Well Name: BURCH KEELY UNIT	Well Location: T17S / R29E / SEC 24 / NESE /	County or Parish/State: EDDY / NM
Well Number: 91	Type of Well: INJECTION - ENHANCED RECOVERY	Allottee or Tribe Name:
Lease Number: NMLC028784A	Unit or CA Name: BURCH KEELY UNIT	Unit or CA Number: NMNM88525X
US Well Number: 3001503069	Well Status: Water Injection Well	Operator: SPUR ENERGY PARTNERS LLC

Notice of Intent

Type of Submission: Notice of Intent	Type of Action: Plug and Abandonment
Date Sundry Submitted: 03/24/2022	Time Sundry Submitted: 01:51
Date proposed operation will begin: 04/15/2022

Burch Keely Unit #91
Eddy County, NM
API# 30-015-03069

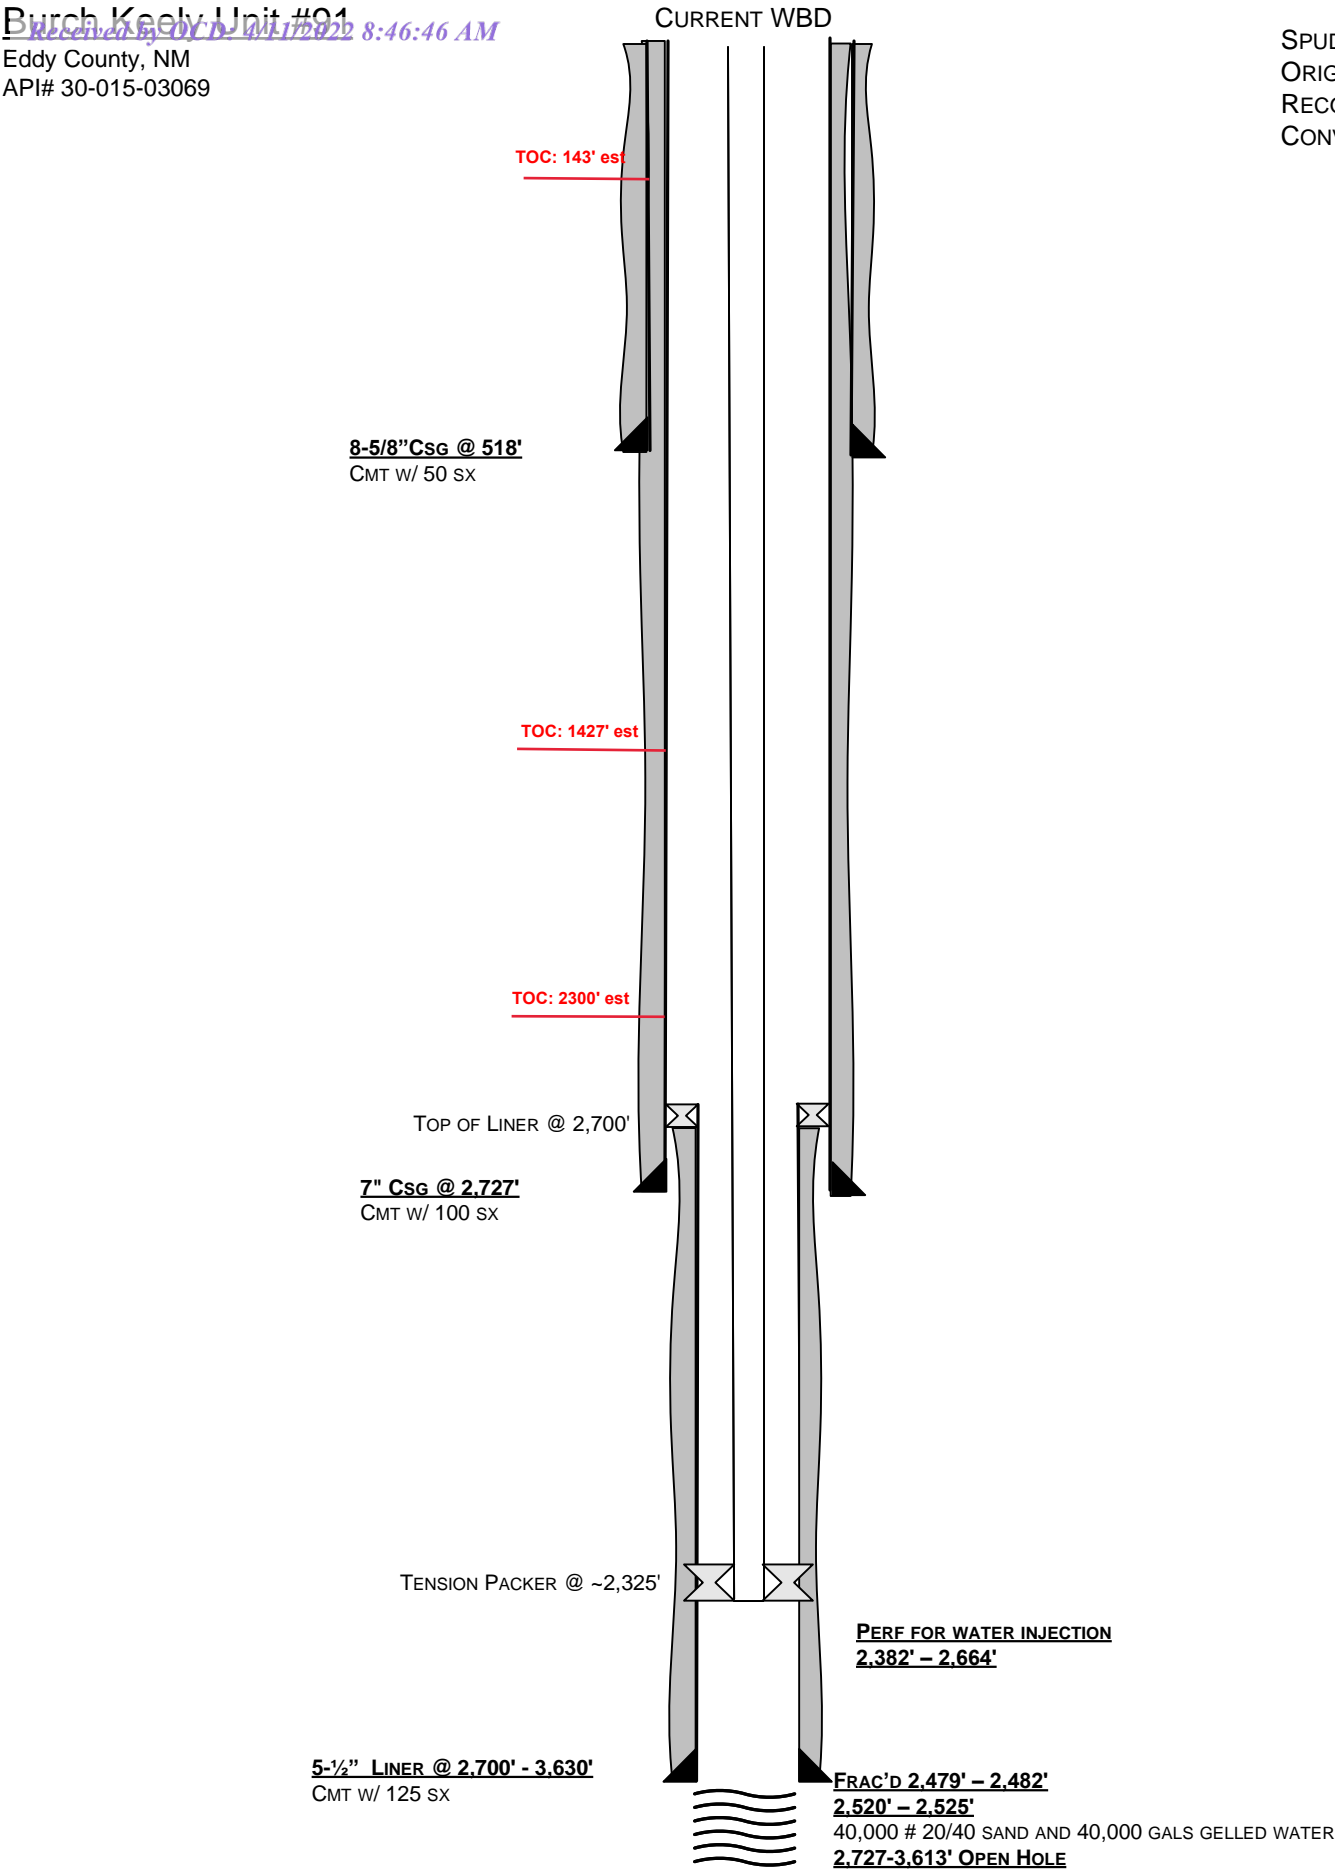
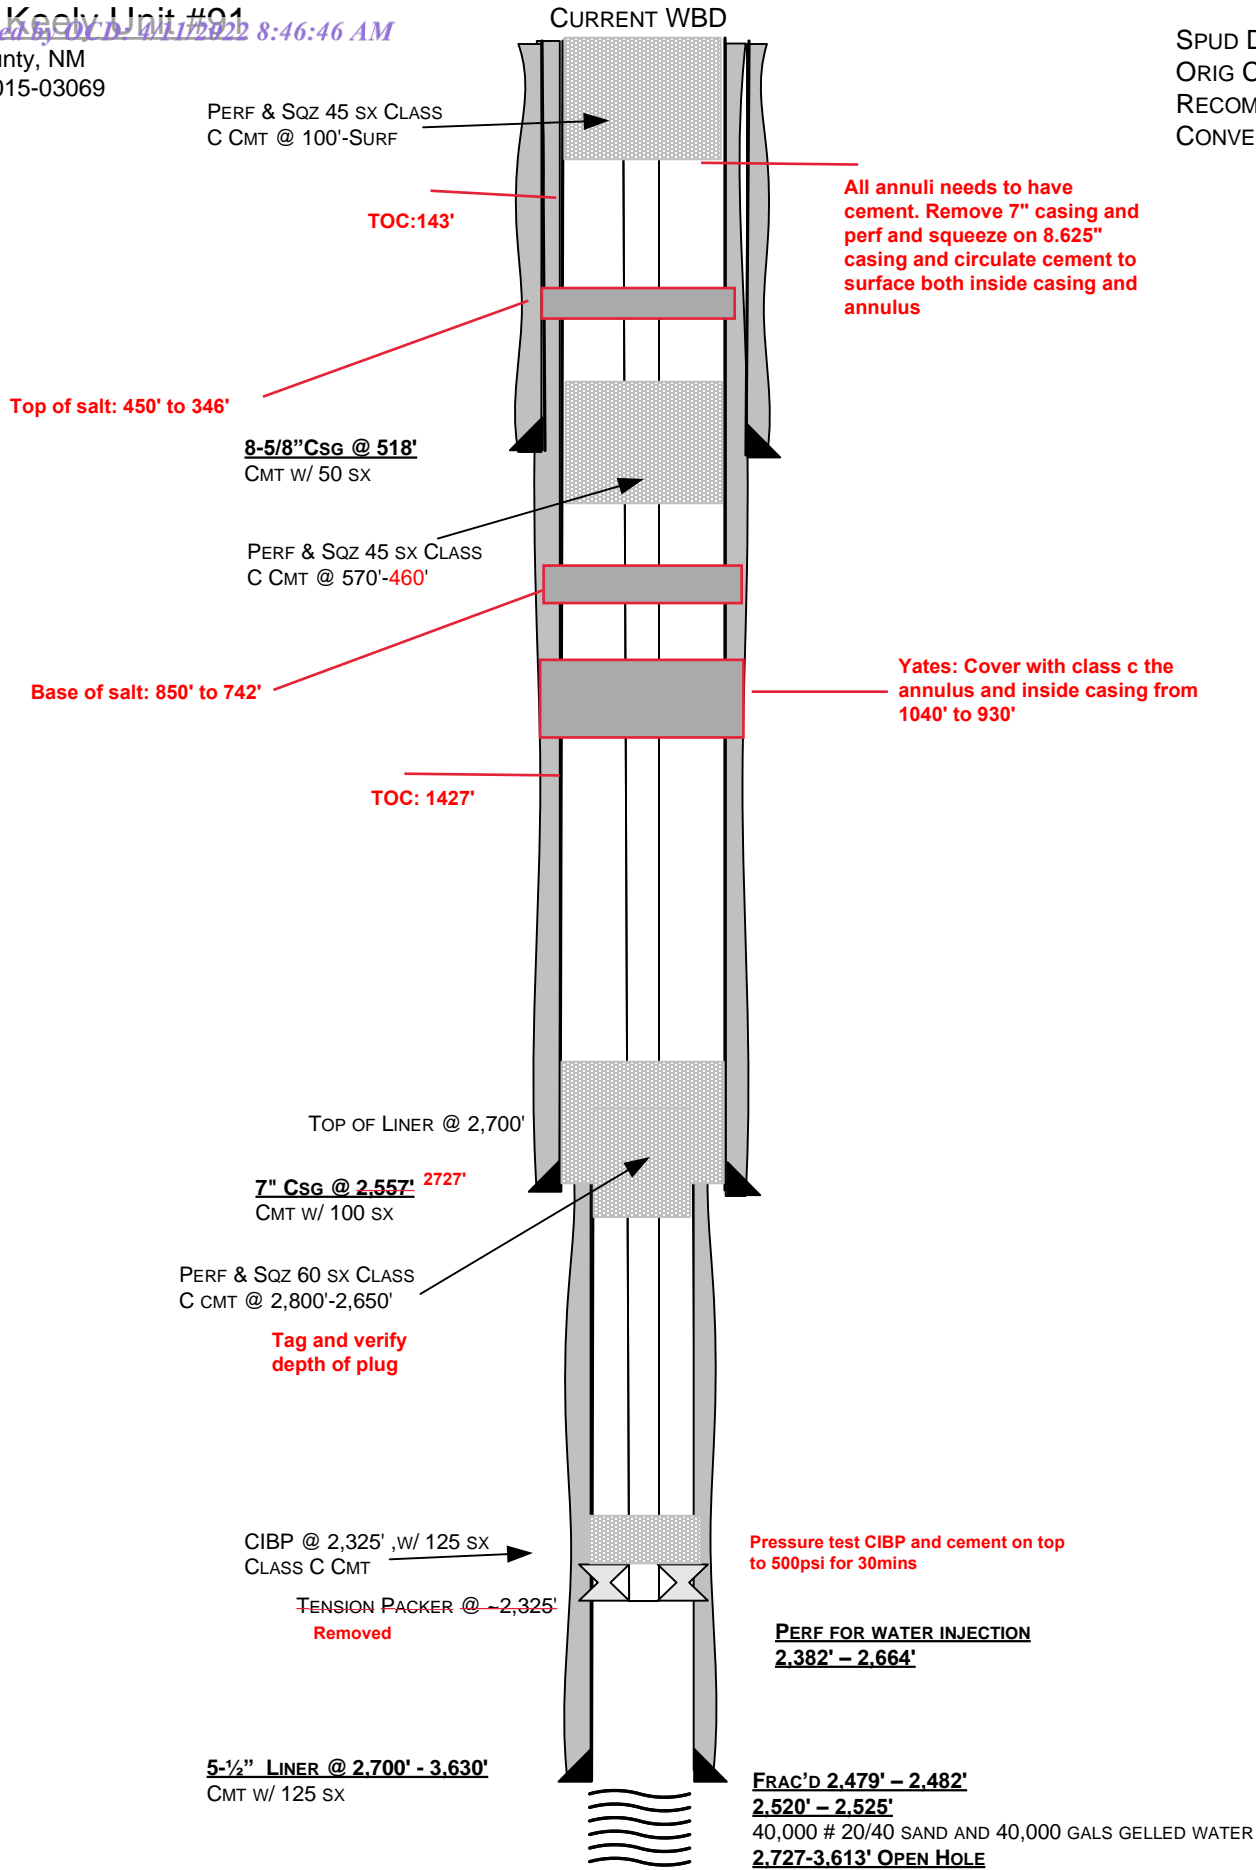
4. Yates: Perf and squeeze 30sx with base at 1040'. Minimum 10sx in annulus and 20sx inside casing. Tag and verify plug top is 930' or shallower
5. Base of Salt: Perf and squeeze 30sx of cement with base at 850'. 10sx in annulus and 20sx inside casing minimum. Tag and verify top of plug is 742' or shallower

6. Perf & Sqz 45 sx Class C cmt @ 570'-460'. WOC & Tag. (8-5/8" Shoe)
7. Top of salt: Perf and squeeze 30sx of cement with base at 450'. 10sx in annulus and 20sx inside casing minimum. Tag and verify top of plug is 346' or shallower. Adjust 8-5/8" shoe plug to include this plug if more practical.

8. Surface plug: All annuli for prescribed depths needs to be cemented. Estimated TOC for the 8.625"-10" annulus is 143'(50sx at 1.06FT³/sack.) Remove 7" casing and perf and squeeze on 8.625' casing with base below 100'. Circulate and top of to surface both in the 8.625"-10" annulus and inside the 8.625" casing.

9. ~~Perf & Sqz 45 sx Class C cmt @ 100' Surf.~~
10. Cut off wellhead, verify cmt to surface, weld on dry hole marker.

Plug Type	Top	Bottom	Length	Tag	Sacks	Notes
Shoe Plug	2649.73	2777.00	127.27	Tag/Verify	25.00	Spot from 2777' to 2649' Class C
Yates @ 990	930.10	1040.00	109.90	If solid base no need to Tag (CIBP present and/or Mechanical Integrity Test), If Perf & Sqz then Tag, Leak Test all CIBP if no Open Perforations	30.00	Perf and squeeze with 30sx and base at 1040'. 10sx in annulus and 20sx inside casing.
Surface Plug	0.00		0.00	Tag/Verify	40.00	All annuli needs to have cement. Remove 7" casing below 100'. Perf and squeeze 8.625" casing and circulate cement to surface from 100' in the annulus and inside casing.
Top of Salt @ 400	346.00	450.00	104.00	Tag/Verify	30.00	Perf and squeeze with 30sx and base at 450'. 10sx in annulus and 20sx inside casing.
Base of Salt @ 800	742.00	850.00	108.00	Tag/Verify	30.00	Perf and squeeze with 30sx and base at 450'. 10sx in annulus and 20sx inside casing.
Fresh Water @ 235	182.65	285.00	102.35	If solid

Shoe Plug	462.82	568.00	105.18	Tag/Verify	30.00	Perf and squeeze with 30sx and base at 450'. 10sx in annulus and 20sx inside casing.

If solid base no need to Tag (CIBP present and/or Mechanical Integrity Test), If Perf & Sqz then Tag, Leak Test all CIBP if no Open Perforations		
CIBP Plug	2290.00	2325.00	35.00		25.00	Spot 25sx and pressure test to 500psi for 30mins
